SUBJECT: 2021 5010-1 Airport Inspections conducted 22 July 2021.

(04214.\*A Mahoney Creek Airport – 0U3 Mahoney Creek USFS) (04244.5\*A Indian Creek Airport – S81 Indian Creek USFS)

## Mahoney Airstrip (0U3)

Pic-2

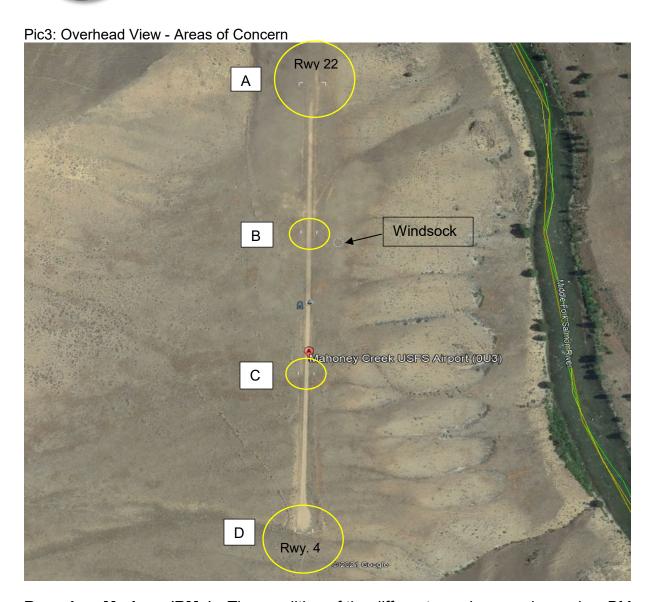
Your runway dimensions reported to the FAA (on the Airport Master Record) and the flying public are: 2150'L x 15'W. However, your BMs in their current position offer a much wider area to use for landings and take-offs than reported. The idea is - you want to stay as close to what the Airport Master Record shows for a couple of reasons: first, as the airport owner, your agency is legally responsible for everything that happens within the BMs, and secondly you have that much more area to maintain/put work into. Picture 3, identifies four different areas you want to look at - address the placement of the BMs located at A, B, C, & D.

Pic-4: Runway End 22

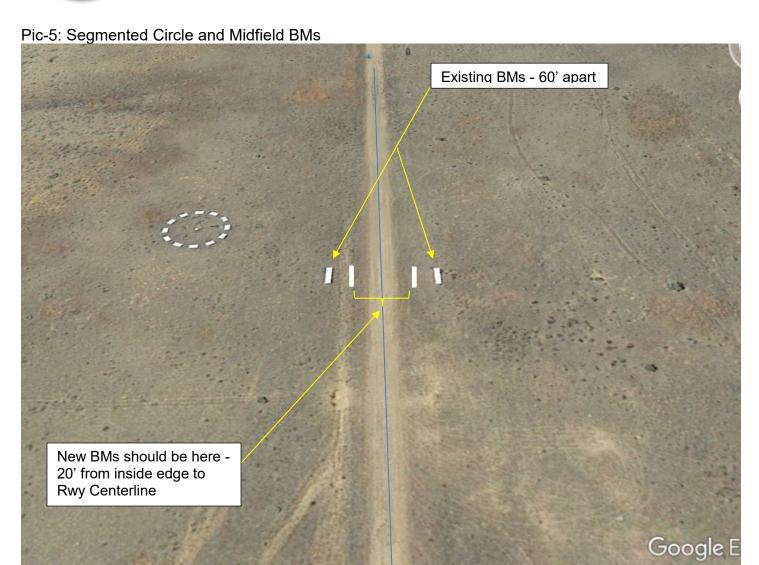
**Boundary Markers (BMs):** The condition of the different wooden panels used as BMs on this airfield is good; however, the condition is not the issue as much as the placement of those markers. Currently, the markers are installed incorrectly and placed too far away from the centerline (see details in pic 4), which is inconsistent with the runway information reported on the FAA's Airport Master Record and certainly not in accordance with the Idaho Transportation Department - VFR Airports Design Manual.

- Area A (Rwy 22)-Pic 4: In-place, bring the BMs towards the rwy center so you would have no more than 25' max from the inside edges to the rwy, centerline, left and right as indicated in pic 4.
- Area B & C-Pic 5: in-place, bring all BMs towards the rwy center to have no more than 20' from the inside edges to therwy, centerline, both - left and right,
- Area D (Rwy 4)-Pic 6: bring the BMs forward 30' from current position and 25' apart from rwy. centerline – see explanation in pic 6.
- The size of the BM panels should be a minimum of 15'Lx4'W, but not smaller; larger is ok (20'x4' or 30'x5')

Pic 14: Area A/Rwy 22

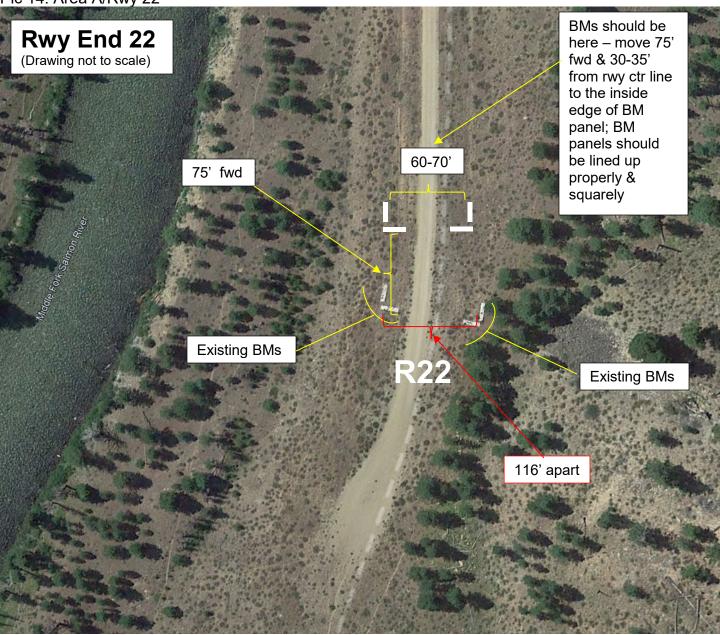
Runway 4-22: Similar to Mahoney Airstrip, this airport too, is in good condition considering its wilderness location and remote access. The dirt/sandy surface is incredibly smooth and without any or major undulations that would negatively affect the stability/ground rollout for either arriving or departing aircraft. Small, loose rocks were present all throughout, but more so, closer to the rwy ends. Everything was in great shape, except the BMs – see pics 9, 10,11 & 12, down below for a visual representation. For example, when approaching from the NE on final to Rwy. 22, I was unable to see the BMs during final approach..... it wasn't till the very last second, when I did the little dog leg turn to the left to line up on the straight away for landing (pics 9 & 10), that I saw the right BM. This BM is completely obstructed from pilot's view by the 40-60' tall evergreen trees in front of it. The same goes for Rwy end 4 where the BMs are installed incorrectly as well - left side is on uneven terrain and also obstructed by trees. All the BMs need relocating, simply because currently they are not fully/properly serving the purpose they're designed for and, more importantly, for safety reasons.
